DATE	January 4, 1980	JOB NO.	47-2-0003
ATTENTION	Mr. Subas Shaw, District Engineer		
RE:	Casita Vista Subdivision - Drainage		
RECEIVED			
JAN 6 1980

Re: Casita Vista Subdivision drainage plan

CASITA VISTA

DRAINAGE MANAGEMENT
PLAN

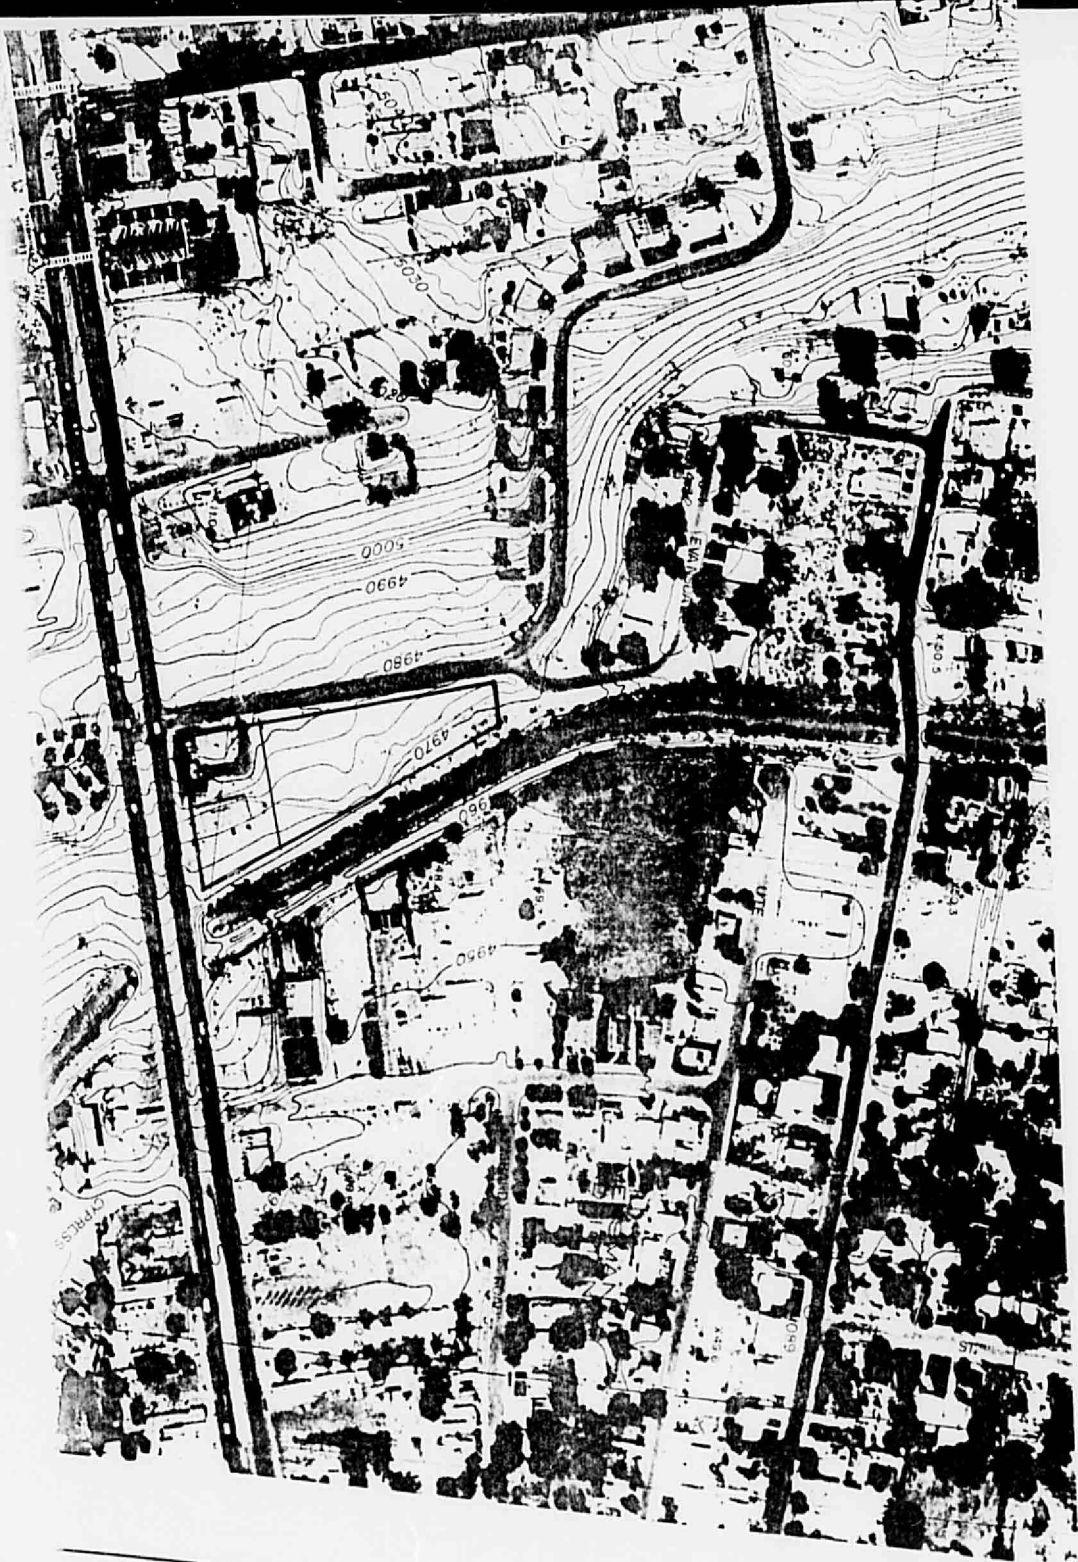
① I CAN NOT AGREE WITH SOME OF THE AREAS DESIGNATED FOR THE DIFFERENT ITEMS ON PAGE FIVE OF THE REPORT. SEE MY CALCULATED AREAS ON PAGE FIVE.

② I DON'T AGREE WITH THE "C" FACTOR DESIGNATED FOR SOUTHWEST LANDSCAPING.

③ THE ITEM DESIGNATED AS PAVING (STREET) DOES NOT AGREE WITH THE AREA I CALCULATED FOR THE CUL-DE-SAC.
(IN REPORT) $370 \text{ sf.} \times 10 \text{ LOTS} = 3700 \text{ sf. TOTAL}$
(MY CALCULATIONS) 5800 sf. TOTAL . SEE GRADING PLAN

* ④ SINCE AN AVERAGE POND REQUIREMENT IS DESIGNATED FOR EACH LOT, I WOULD LIKE TO SEE A BALANCE FOR EACH LOT BETWEEN THE DRAINAGE AREA AND POND. THESE AREAS SHOULD BE OUTLINED AND THE POND VOLUMES CALCULATED (AND SHOWN)

⑤ SINCE U.B.C (UNIFORM BLDG. CODE) IS CONCERNED WITH THE CLOSE PROXIMITY OF THE POND TO THE STRUCTURE, WE SHOULD GET THEIR APPROVAL.

⑥ IS THIS AREA CONSIDERED THE VALLEY?

* ITEM ④ HAS BEEN A CRITICAL PROBLEM REGARDING FINAL INSPECTION IN THE FIELD. DRAINAGE AREAS DESIGNATED ON THE CONCEPTUAL PLAN DOES NOT USUALLY BALANCE WITH THE POND IT IS DRAINING TO.

How about positive drainage?

Ponds adjacent to the canal should be designed against any failures.

Recommend an erosion sedimentation protection plan for this particular development. Our waterways should be protected from any increase in suspended solids and sediment depositing in the canal.

According^x to the FNBW dated 12-4-79, this area is not in a flood hazard zone,
